ADDENDUM

Project: Craft State Office Building -
Chiller Replacement

Project No.: 11115

Addendum No.: 1

ADD 1

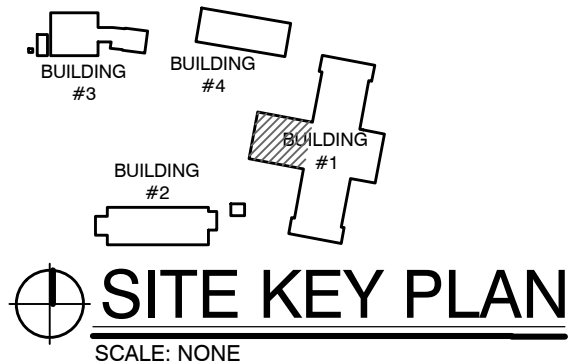
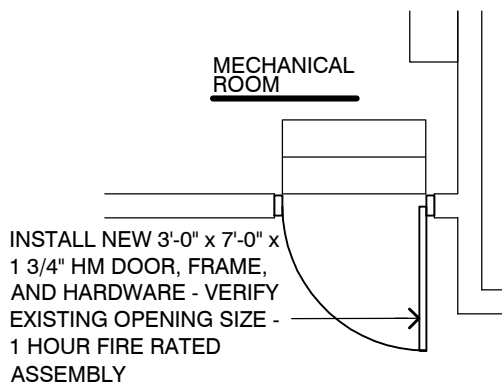
- 1) Mechanical Room, remove door, frame and hardware provide and install new door with all associated hardware as shown on sheet ADD1.

BASEMENT MECHANICAL DEMOLITION PLAN - PHASE 1

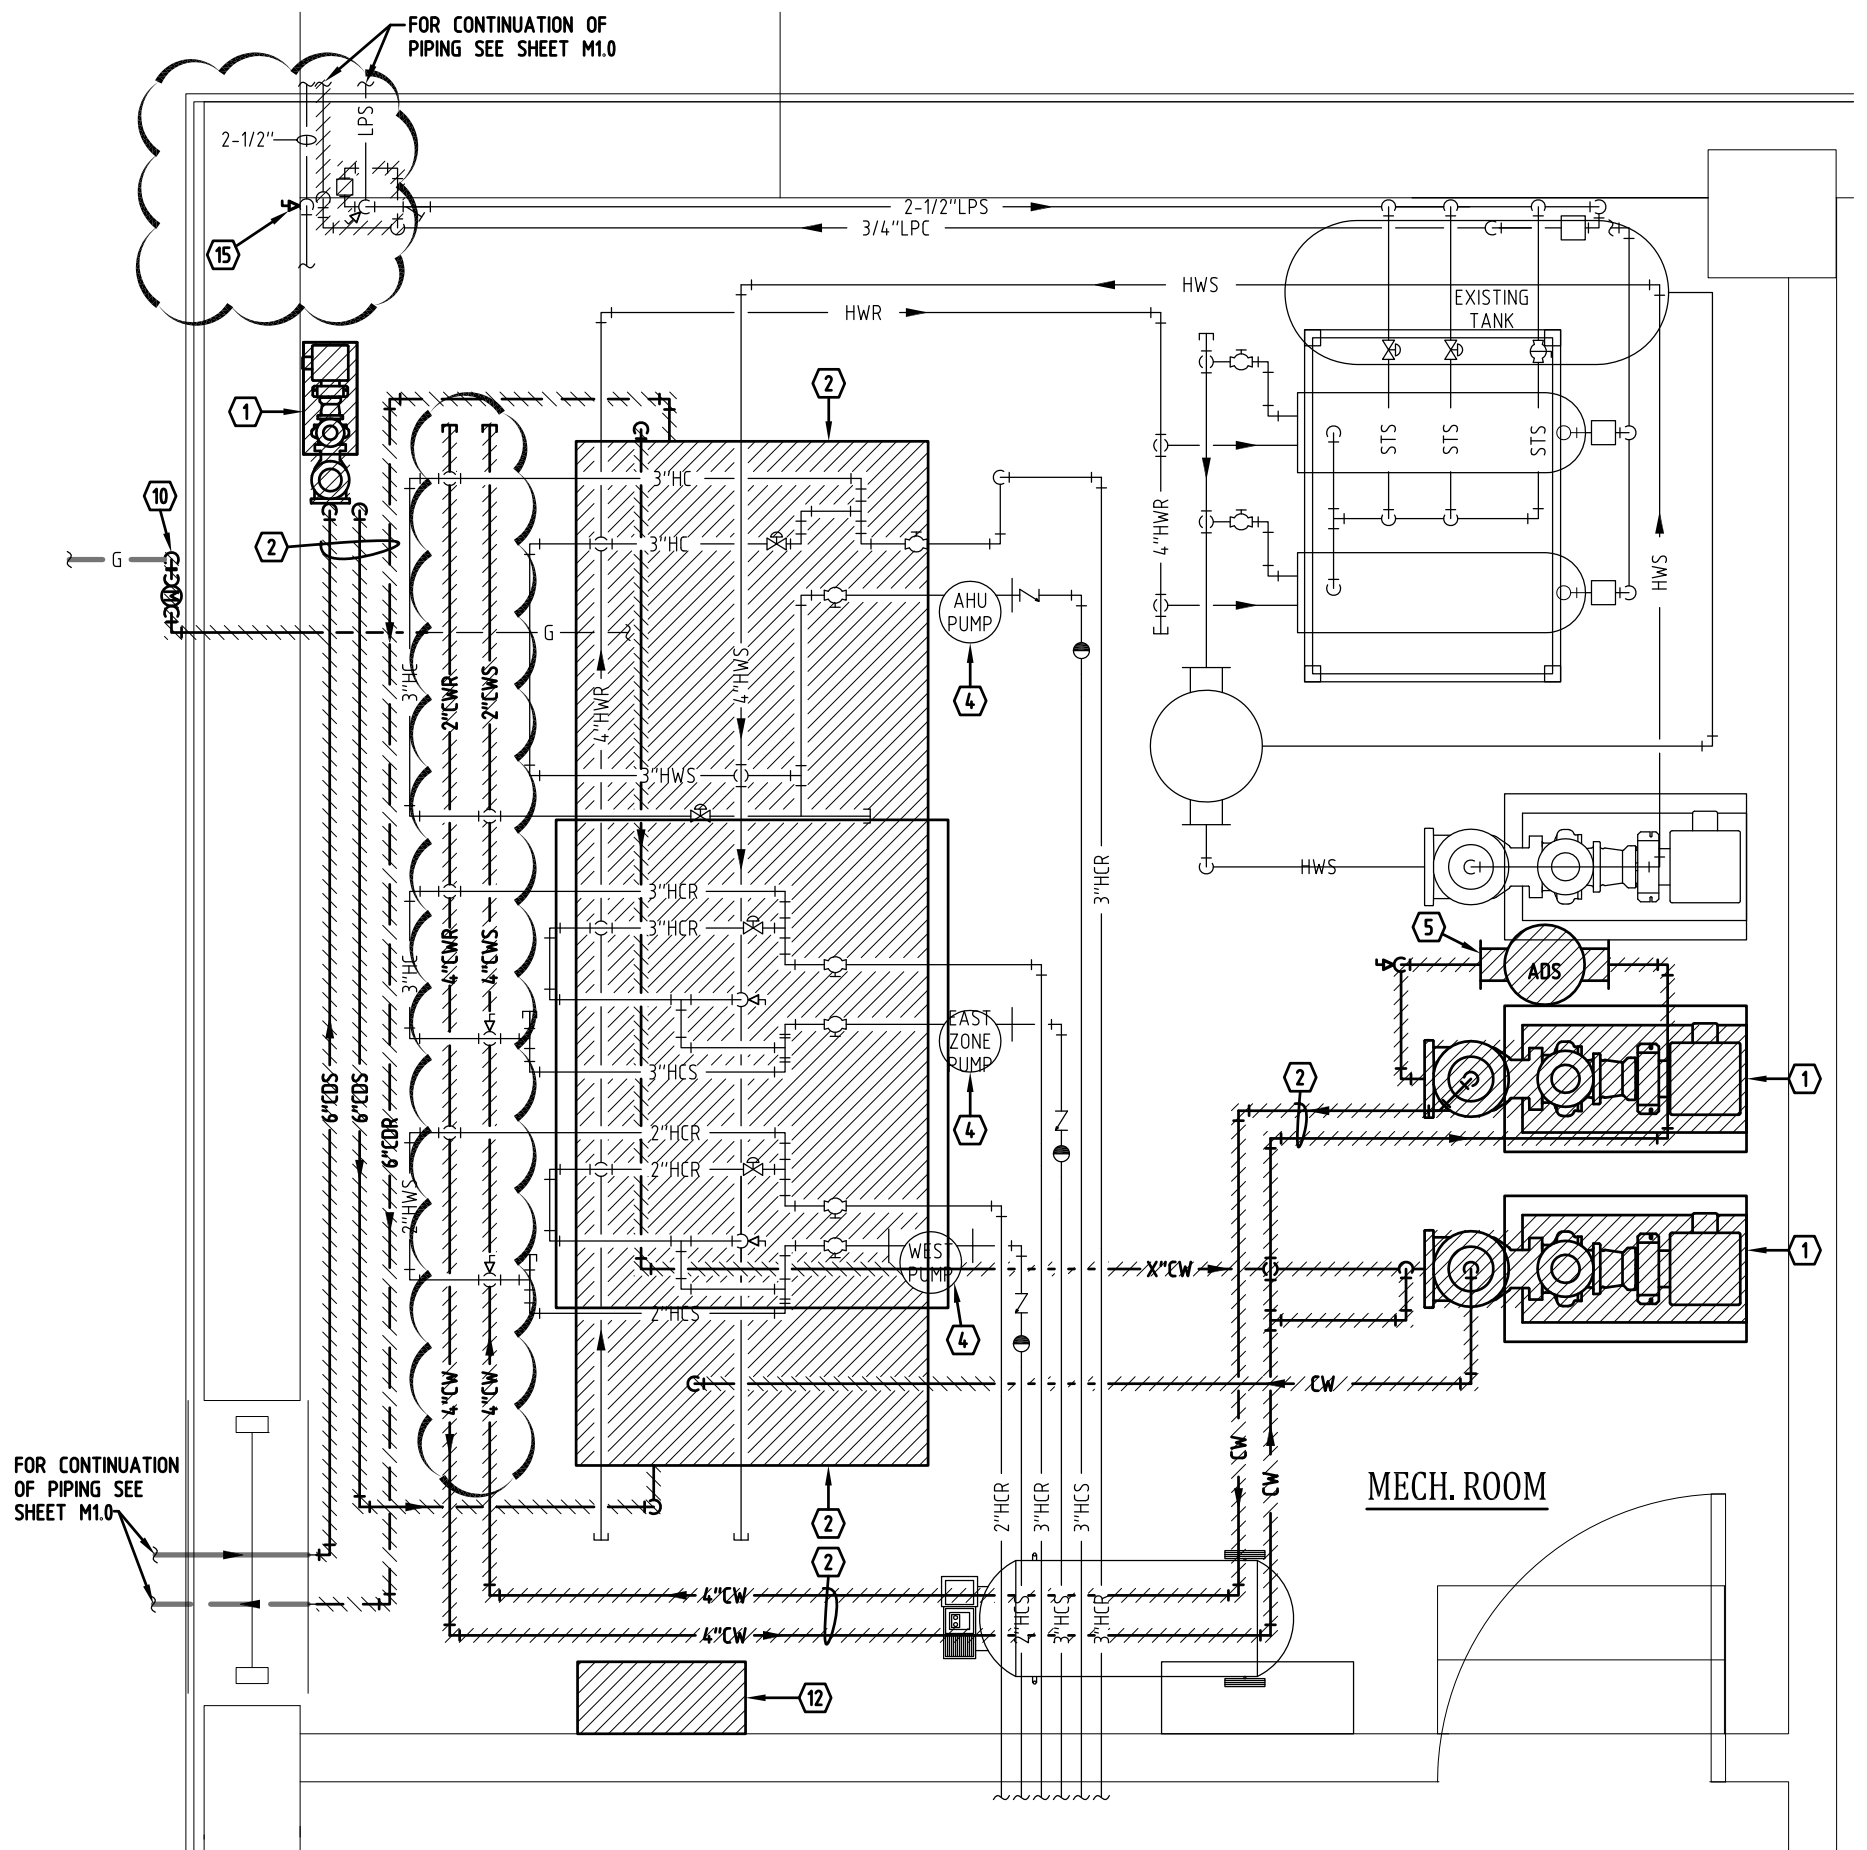
- 1) Remove and replace 2½" domestic cold water isolation valve. Turn off water in building #3. Coordinate with Owner time to change valve because most building #1 domestic cold water will have to be drained. (For Phase-I). See attached M1.1 sheet 1 of 4.
- 2) Re-insulate all existing hot and chilled water supply and return piping that remains in Mechanical Room. See attached M1.1 sheet 3 of 4.
- 3) Note 6 shall be reworded. See attached page 3 of 4 on sheet M1.1.
- 4) Modify chilled and hot water piping as shown on the sheets 1, 2, 3 of 4 on M1.1.

14. REMOVE CONTROL VALVE AND ALL ASSOCIATED PIPING, CONTROLS.
15. REMOVE AND REPLACE 2-1/2" ISOLATION VALVE. TURN OFF WATER IN BUILDING #3. COORDINATE WITH OWNER TIME TO CHANGE VALVE BECAUSE MOST OF BUILDING #1 DOMESTIC COLD WATER WILL HAVE TO BE DRAINED. (PHASE 1)
16. REMOVE EXISTING HUMIDIFIER AND ASSOCIATED HUMIDITY DRAIN PIPING TO EXTENTS POSSIBLE AND CAP. PATCH AND REPAIR AHU.
17. REMOVE AND REPLACE FRESH AIR DAMPER CONTROLLER IN DUCT TO AHU. REMOVE AND REPLACE ALL ASSOCIATED CONTROLS WITH DDC CONTROLLED DAMPER. VERIFY REQUIREMENTS IN FIELD BEFORE PROCEEDING.
18. REMOVE AND REPLACE 2" CONTROL VALVE WITH NEW DDC CONTROL VALVE.

3RD FLOOR MECHANICAL ROOM - PHASE 1 & PHASE 2

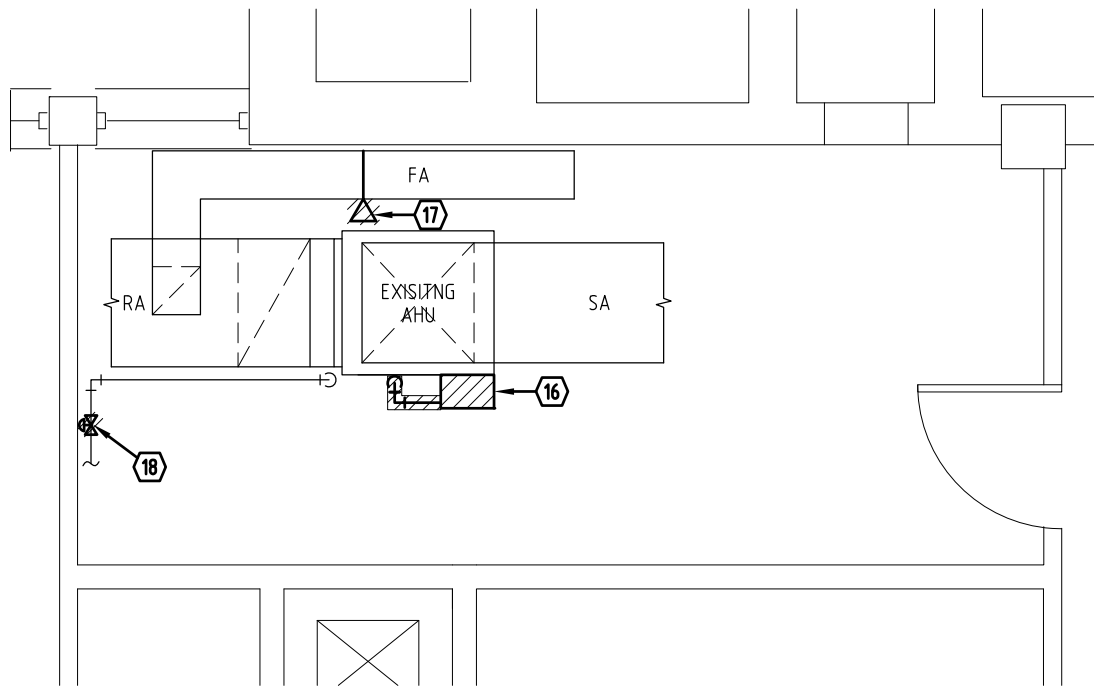
B. Third Floor Mechanical Room (See attached M1.1 sheet 4 of 4.)

- 1) Remove and replace damper actuator in FA duct with new DDC actuator.
- 2) Remove existing humidifier and associated piping to extends possible and cap. Patch and repair AHU.
- 3) Remove and replace 2" control valve with new DDC control valve. (Control contractor to provide control valve)

BUILDING #3 MECHANICAL PLAN - PHASE 2

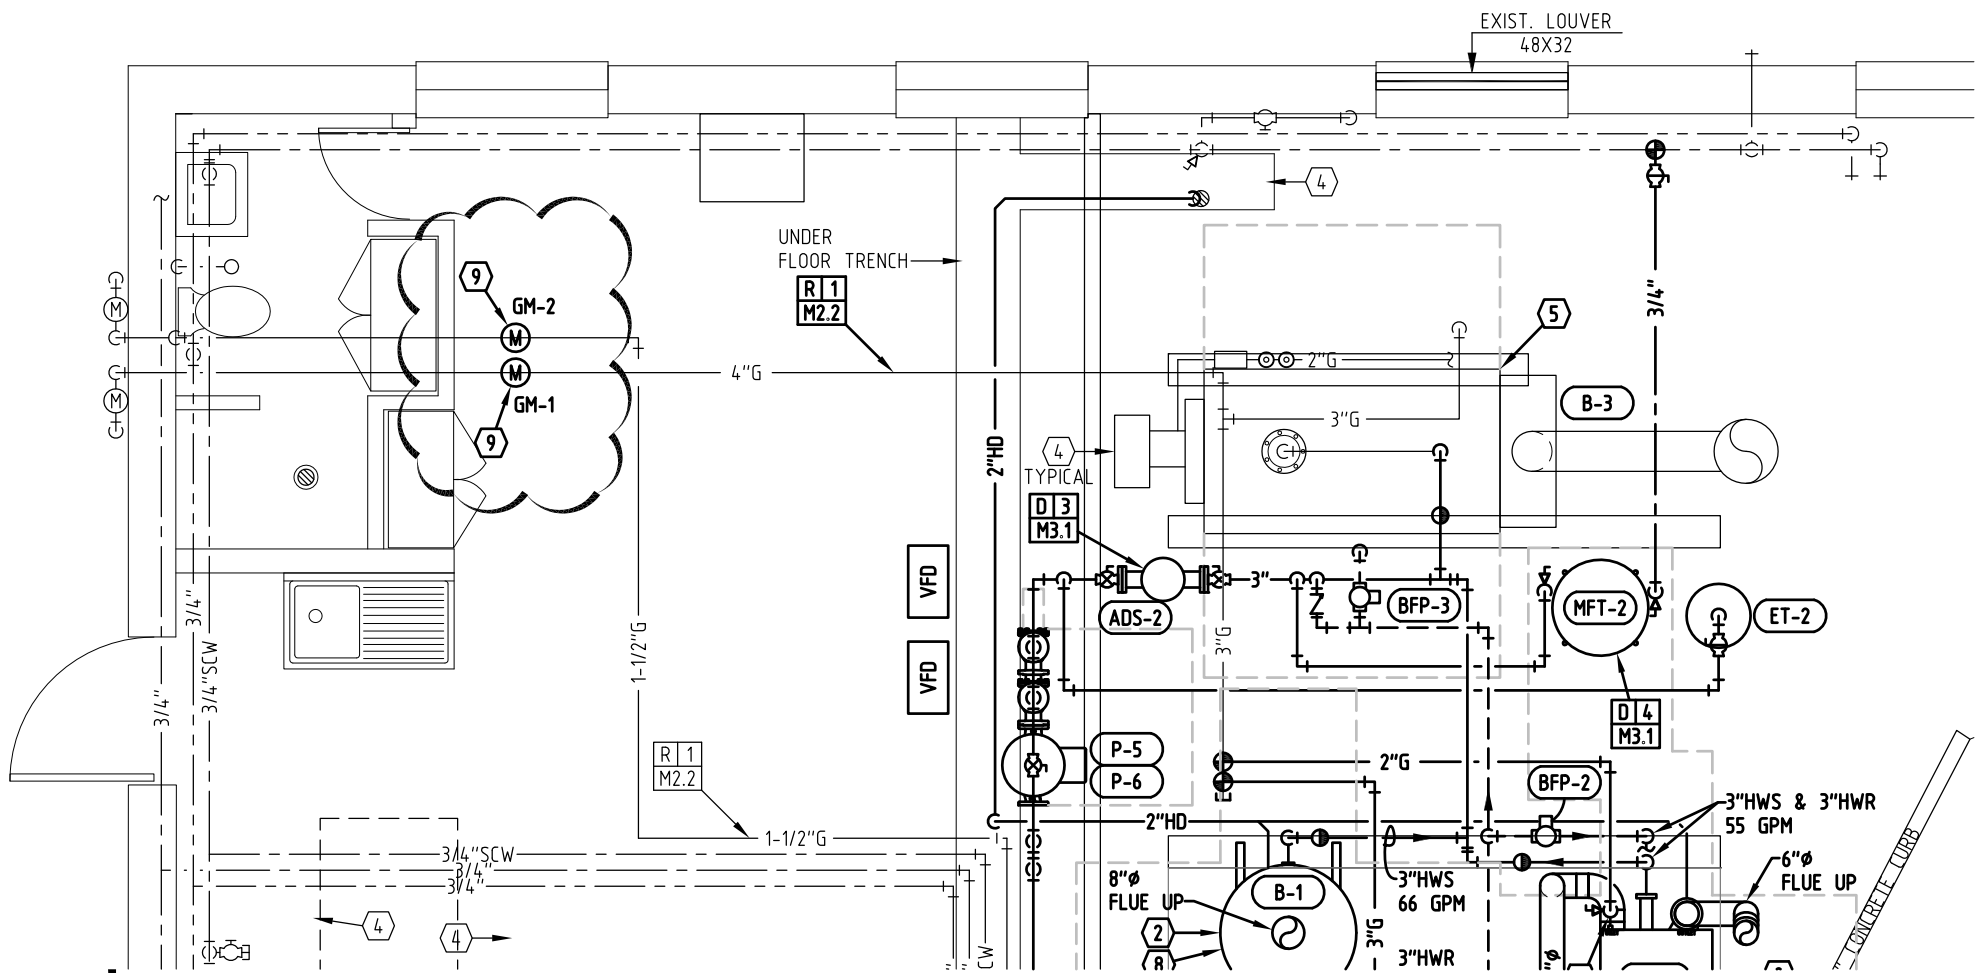
- 1) New note #9 shall read "INSTALL BTU METER IN GAS PIPING. INSTALL PER MANUFACTURERS RECOMMENDATIONS. METER PROVIDED BY CONTROLS CONTRACTOR INSTALLED BY MECHANICAL CONTRACTOR. PROVIDE STRAIGHT RUN OF PIPE 15 TIMES PIPE DIAMETER UP STREAM OF METER AND 5 TIMES PIPE DIAMETER DOWN STREAM OF METER. METER TO BE INSTALLED UNDER ALTERNATE M-1". See attached M2.2 sheet 1 of 1.

9. INSTALL BTU METER IN GAS PIPING. INSTALL PER MANUFACTURERS RECOMMENDATIONS. METER PROVIDED BY CONTROLS CONTRACTOR INSTALLED BY MECHANICAL CONTRACTOR. PROVIDE STRAIGHT RUN OF PIPE 15 TIMES PIPE DIAMETER UP STREAM OF METER AND 5 TIMES PIPE DIAMETER DOWN STREAM OF METER. METER TO BE INSTALLED UNDER ALTERNATE M-1.

D 4 CONTROLS SCHEMATIC

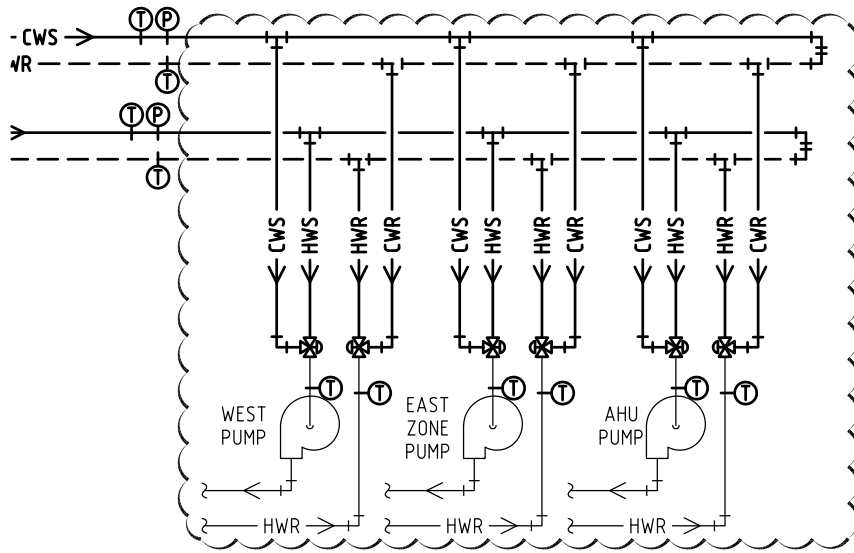
- 1) Shall read "All motors (Gas, Btu, and Electrical) to be provided under Alternate." See attached page 1 of 1 on sheet M3.2.
- 2) See revised control schematic as shown on attached page 1 of 1 on sheet M3.2.

ELECTRICAL ONE-LINE DIAGRAM

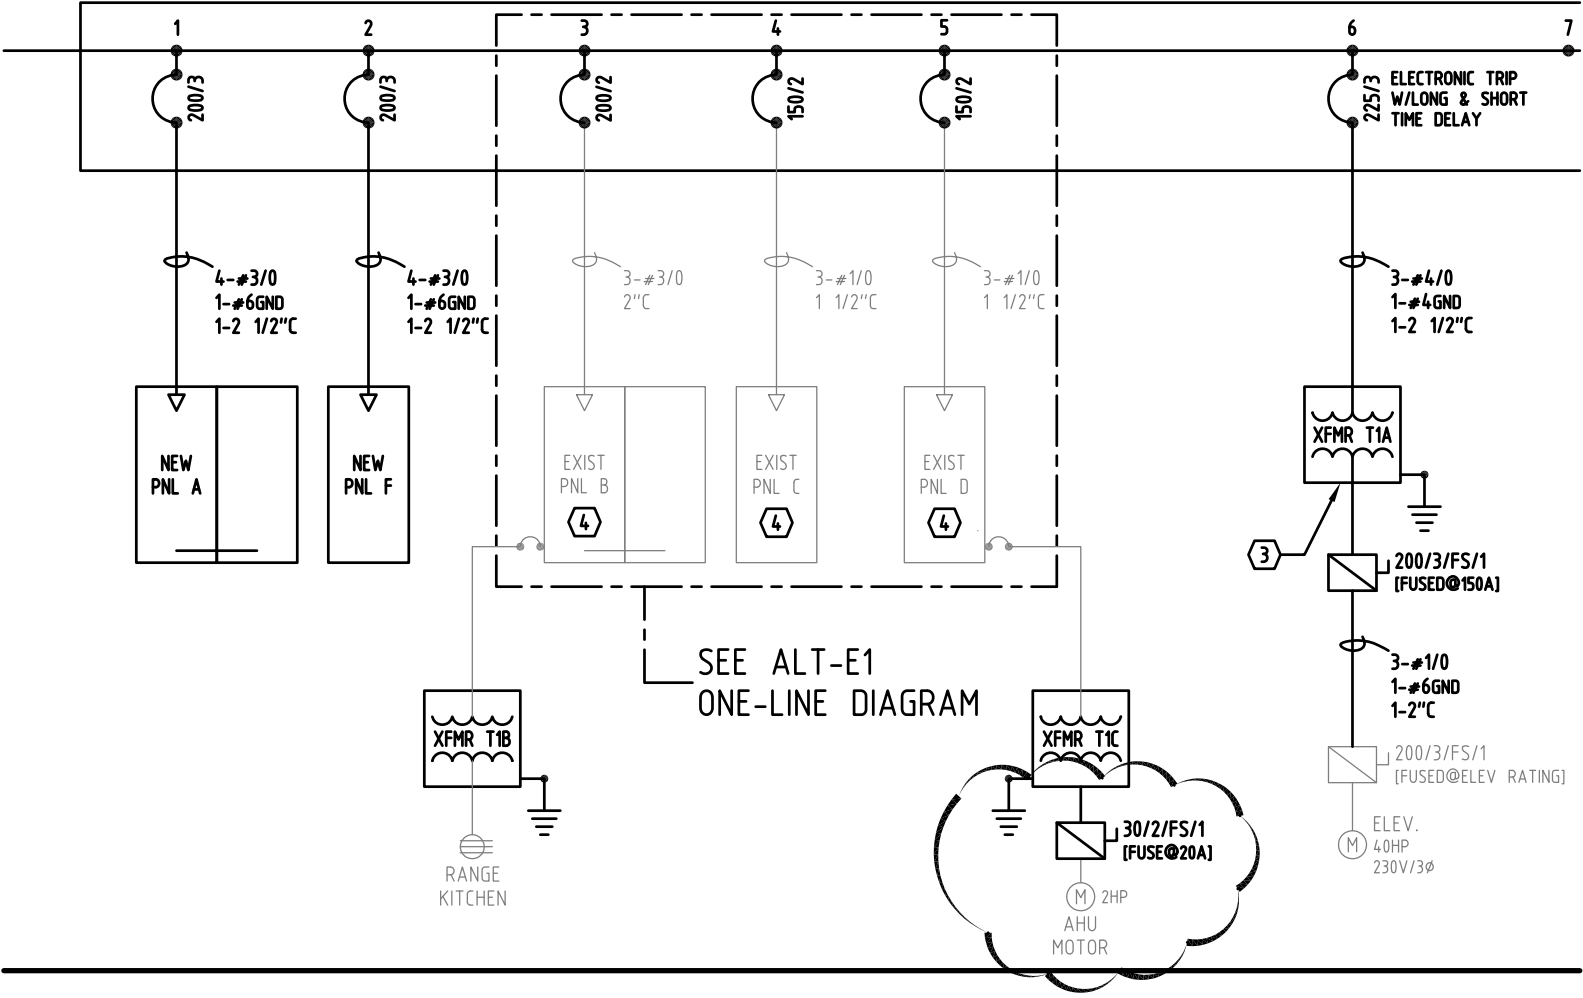
- 1) At building 1, add 30A fused disconnect after transformer T1C. Fuse at 20A. See attached drawing AD01.E32S-1.
- 2) Aluminum conductors are acceptable for service entrance only. Contractor will be responsible for upsizing conduit/wire as required per NEC.
